3.2 Water Resources

Figure 3.2-20

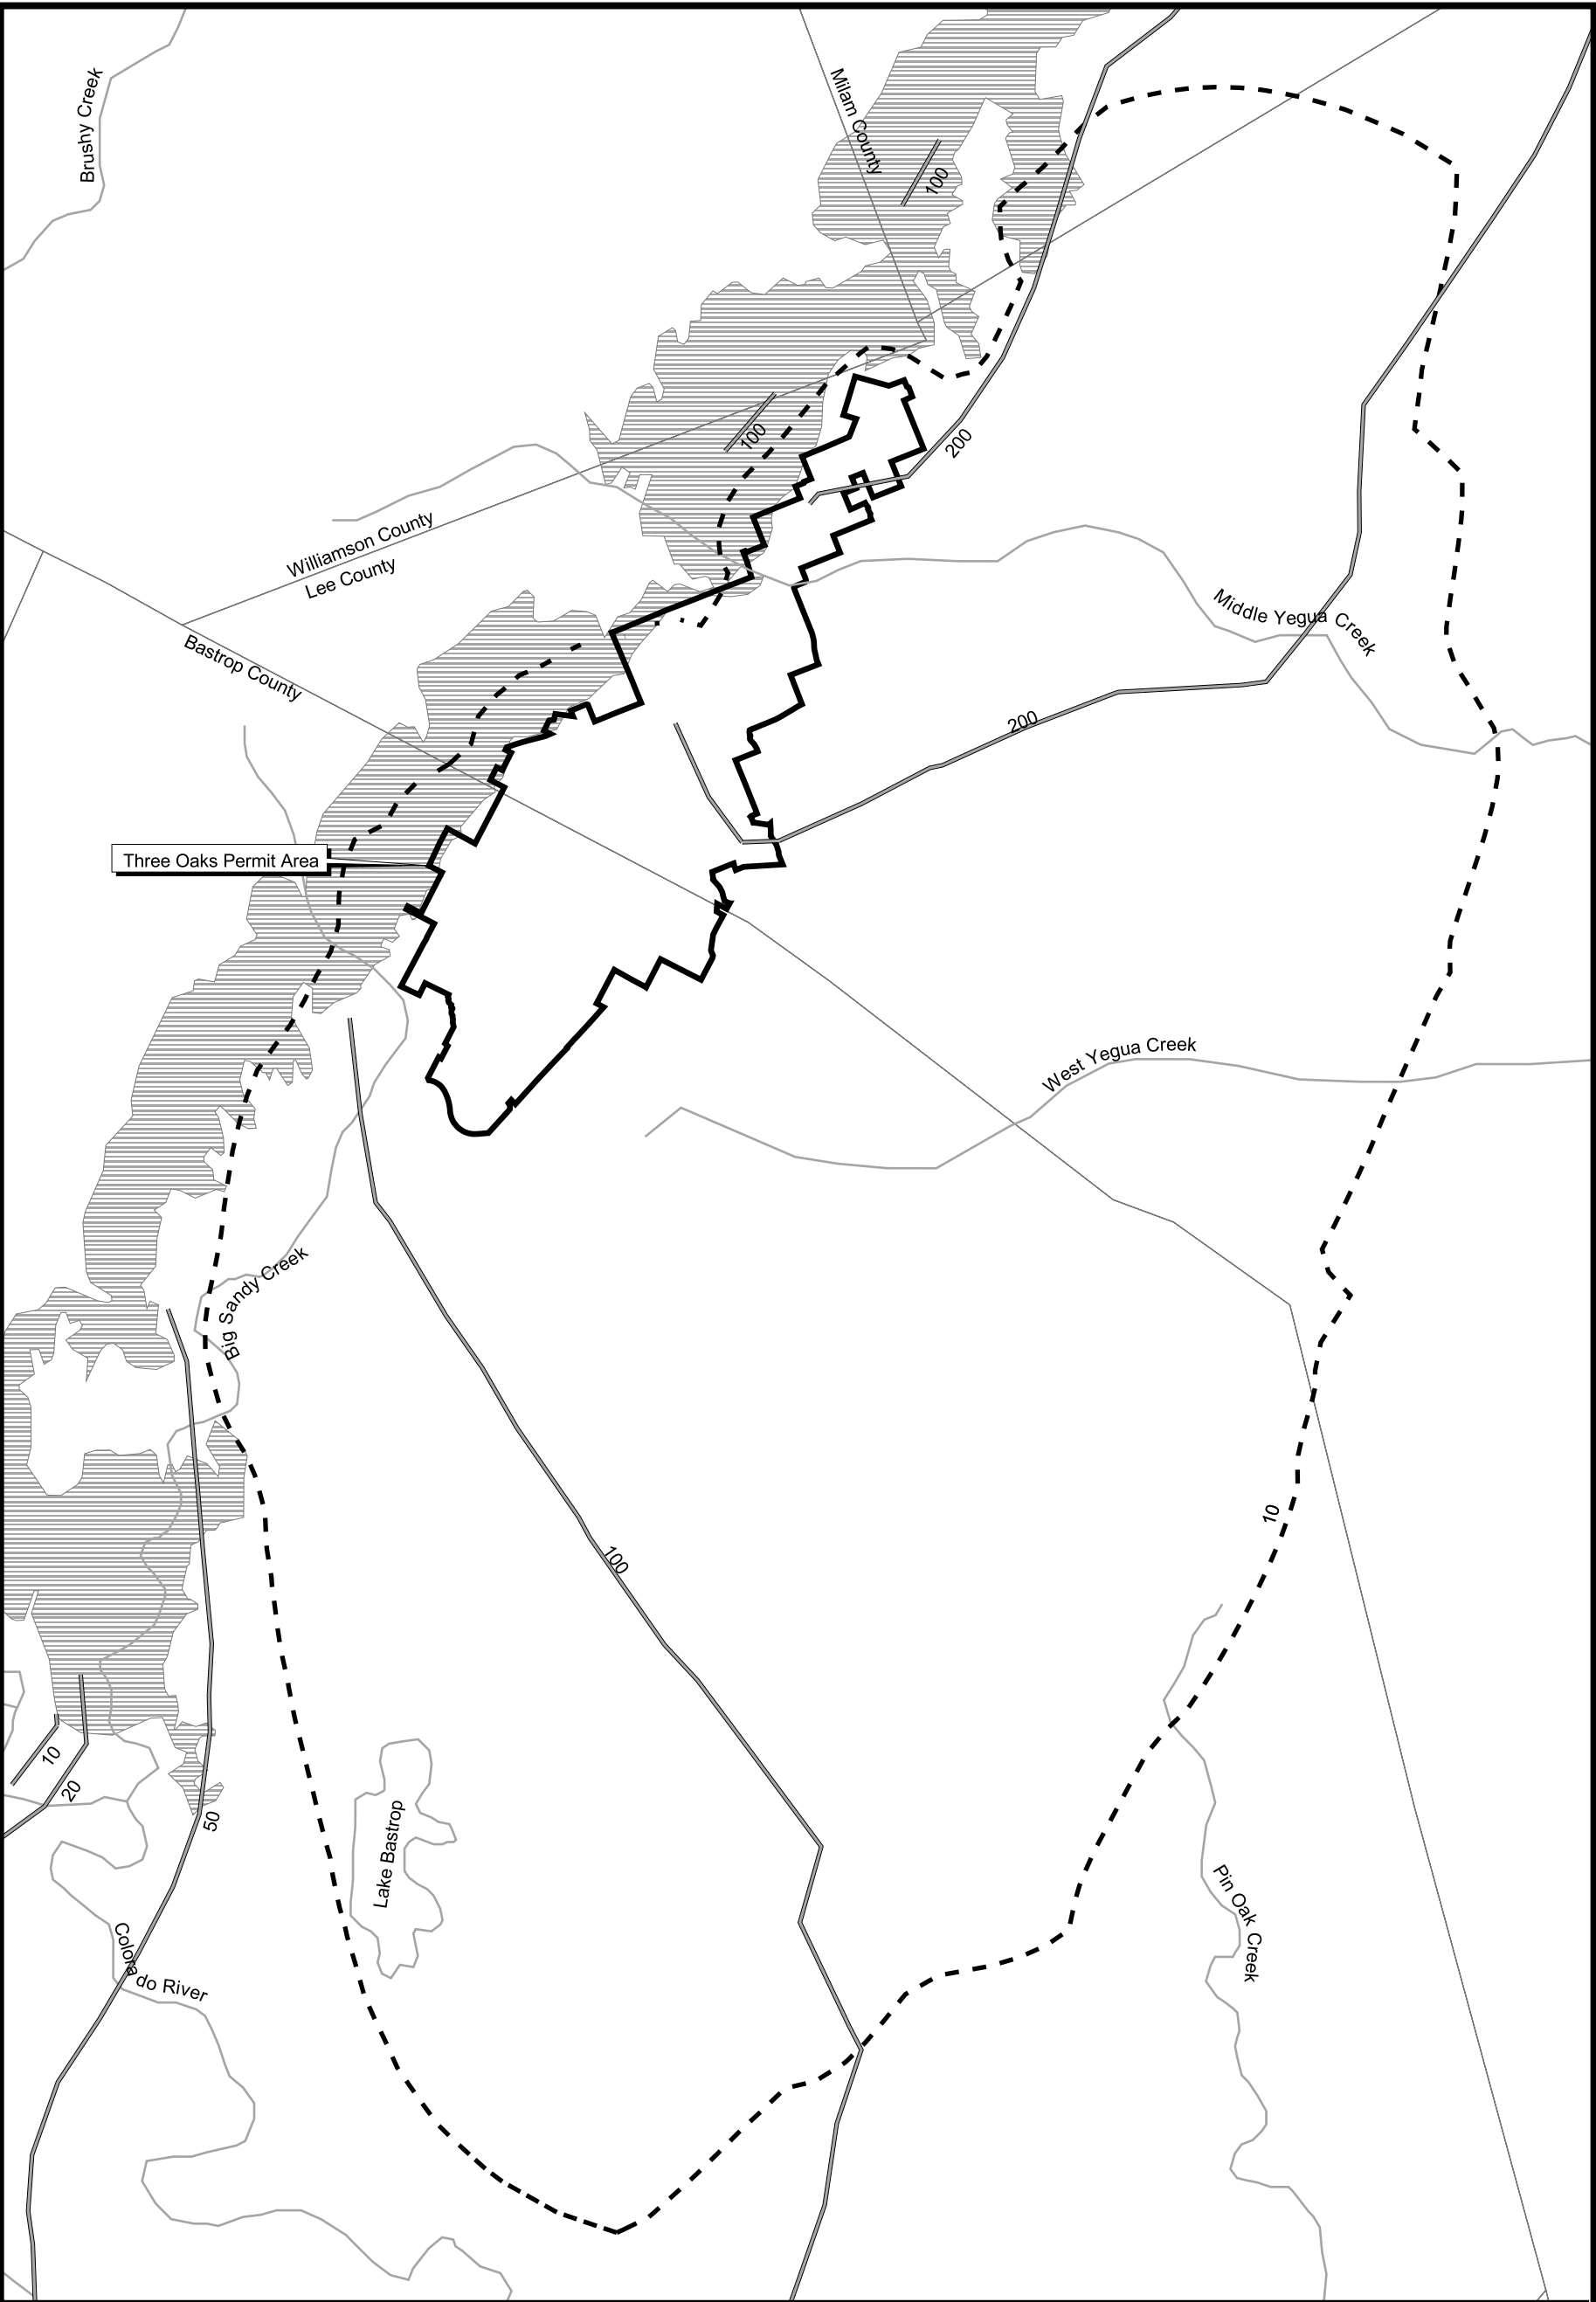
Figure revision: Revised note regarding Three Oaks Mine drawdown.

Figure 3.2-23

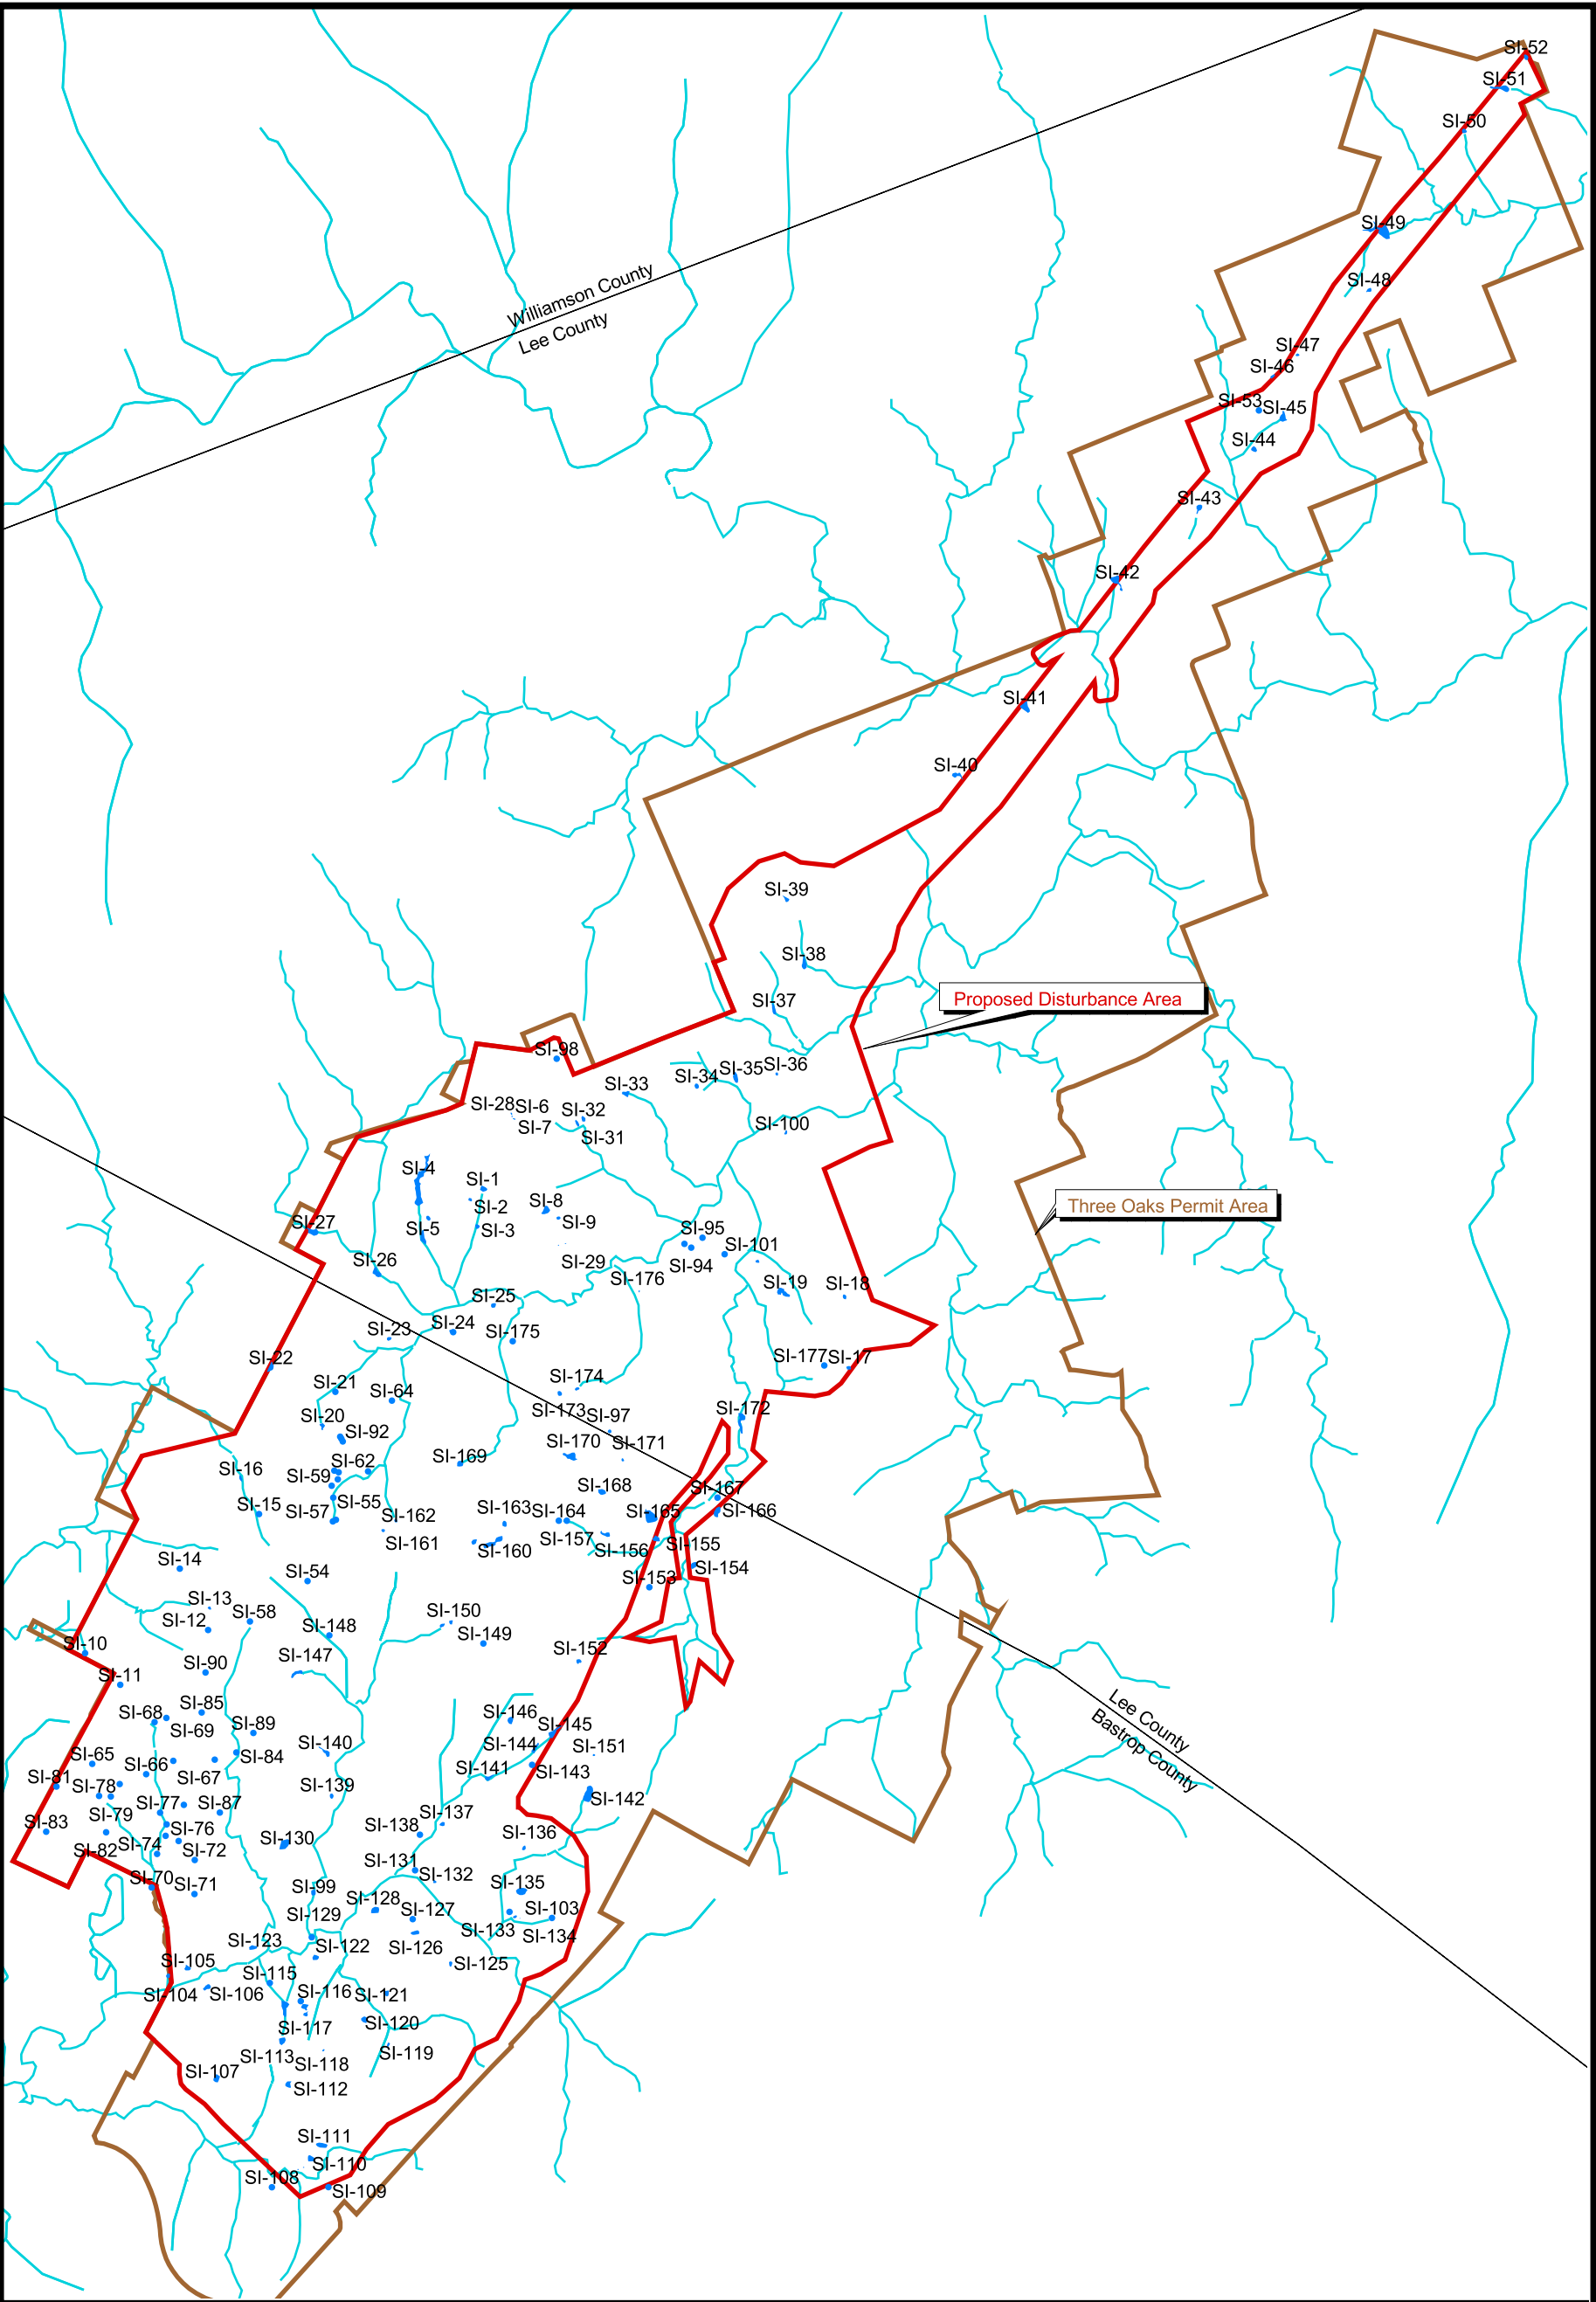
Figure revision: Revised disturbance area for transportation and utility corridor crossing of Middle Yegua Creek.

Figure 3.3-1

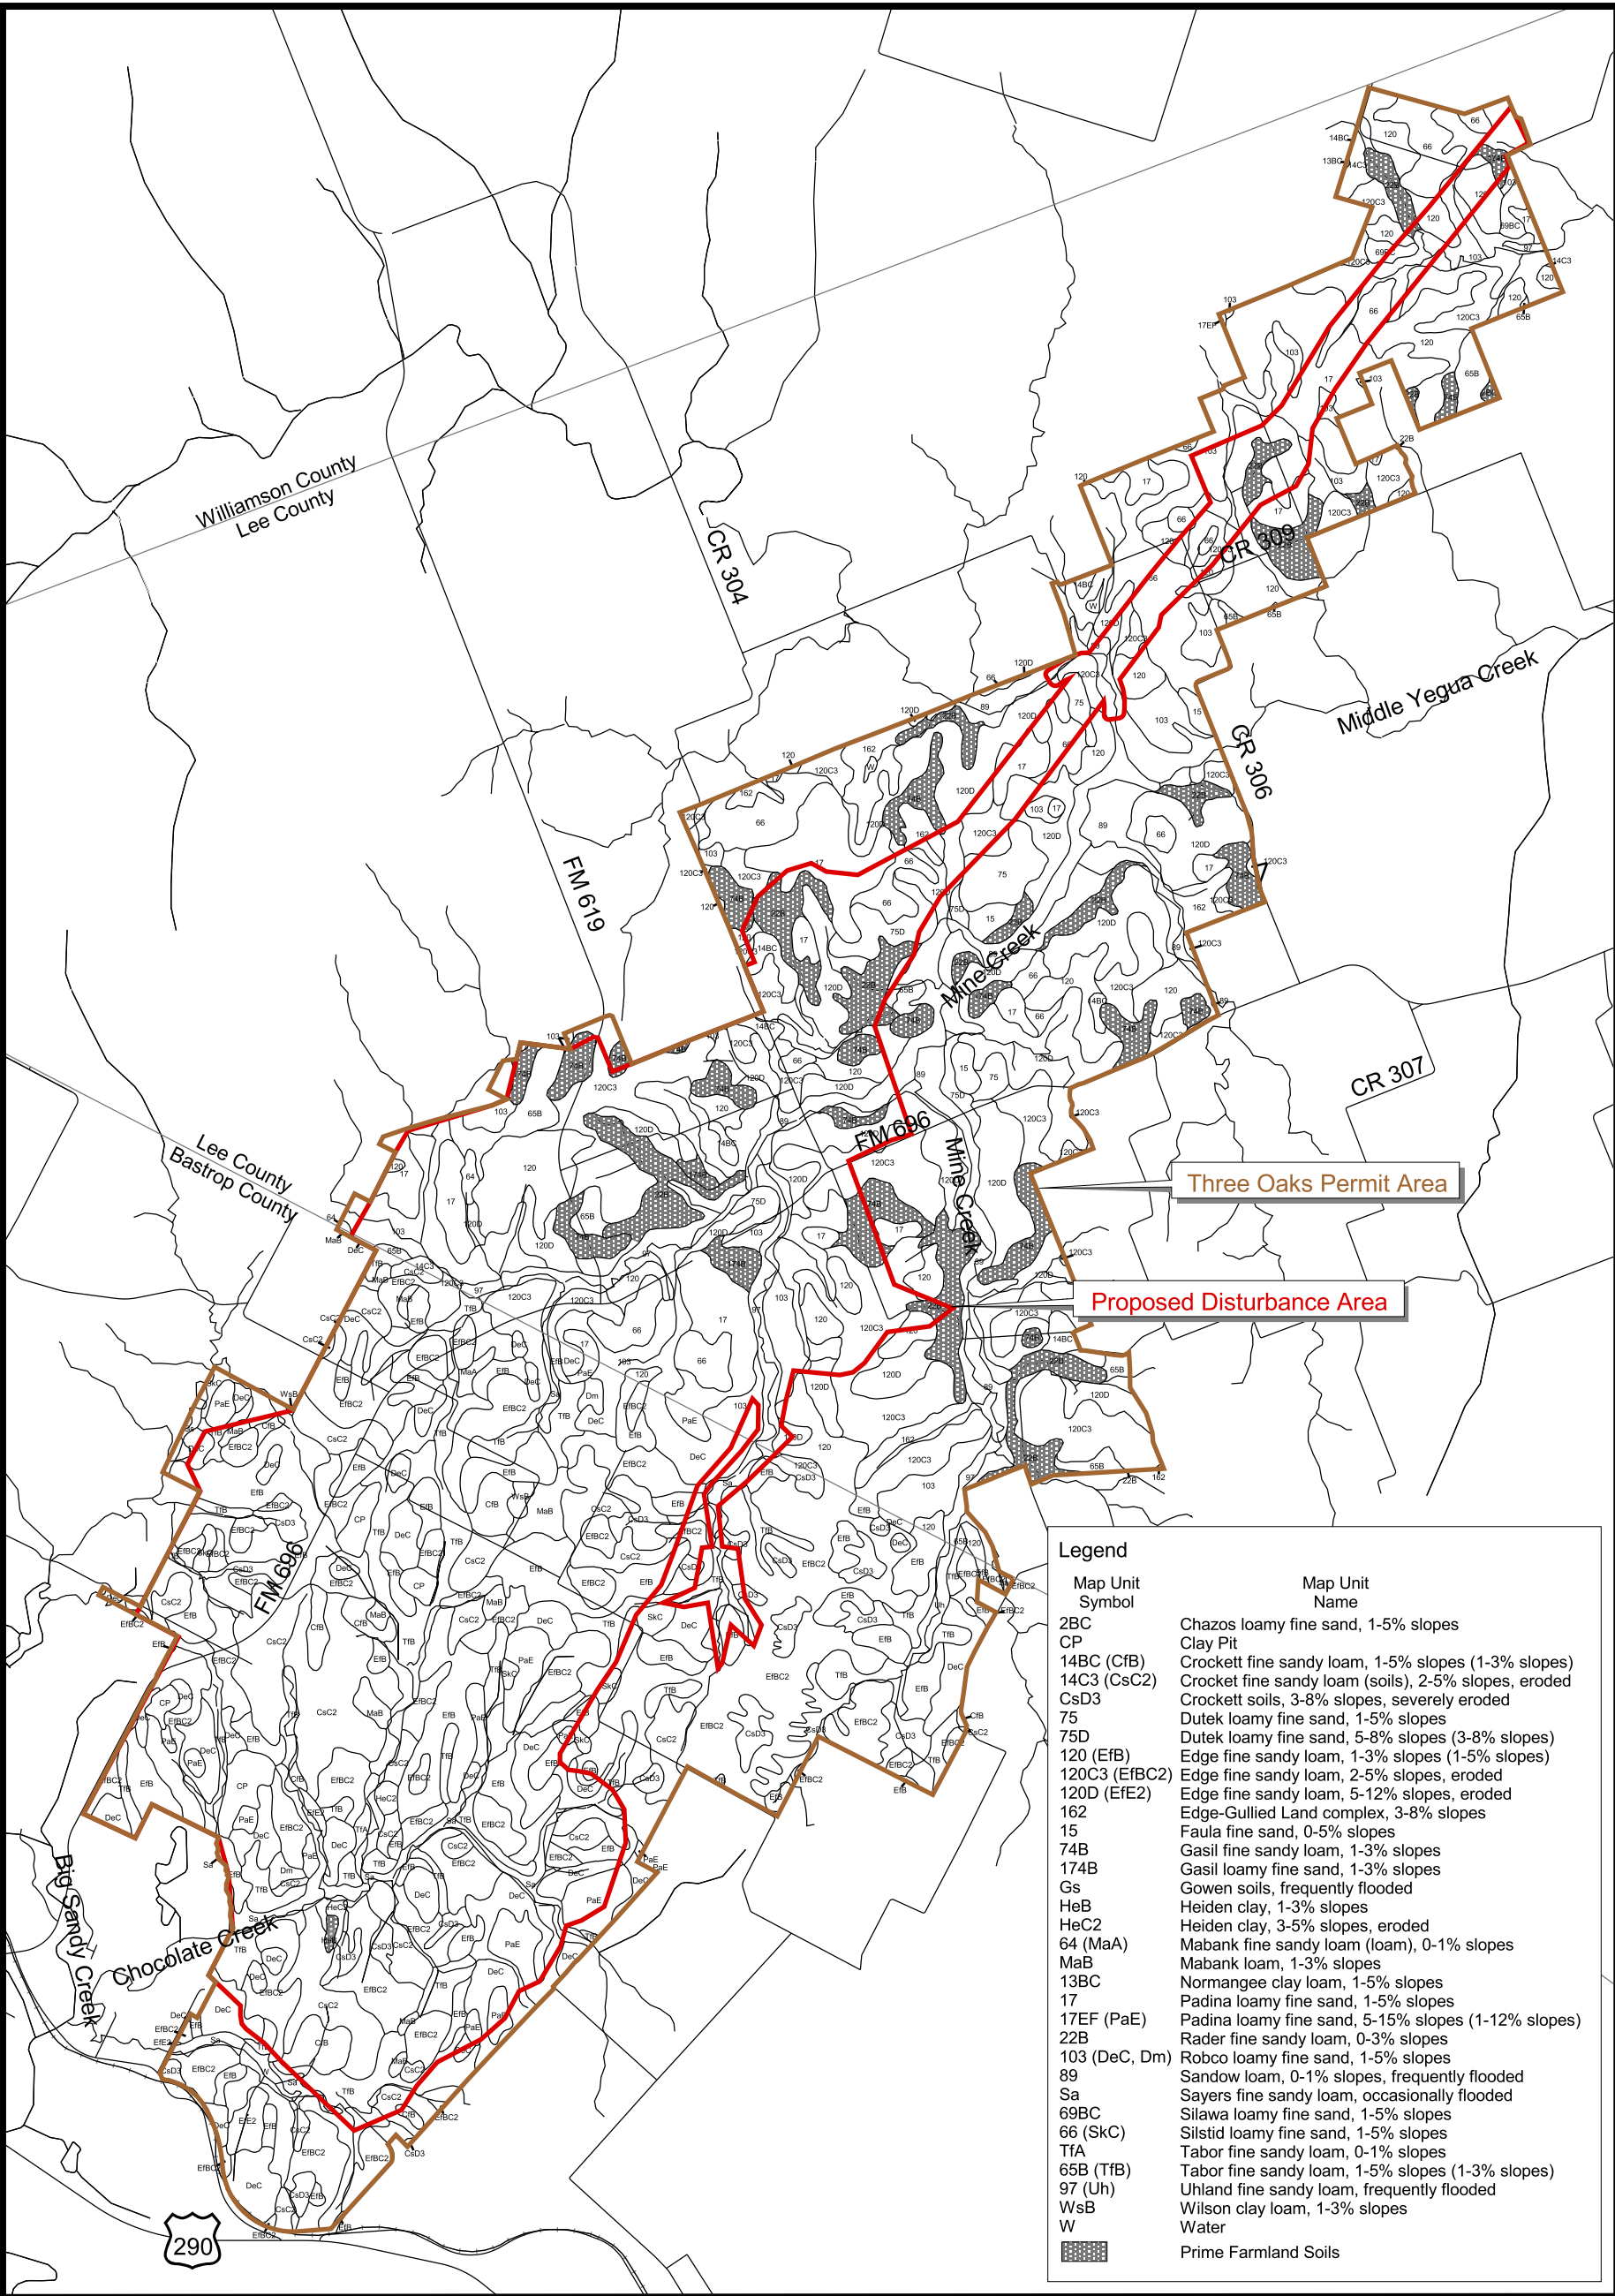
Figure revision: Revised disturbance area for transportation and utility corridor crossing of Middle Yegua Creek.
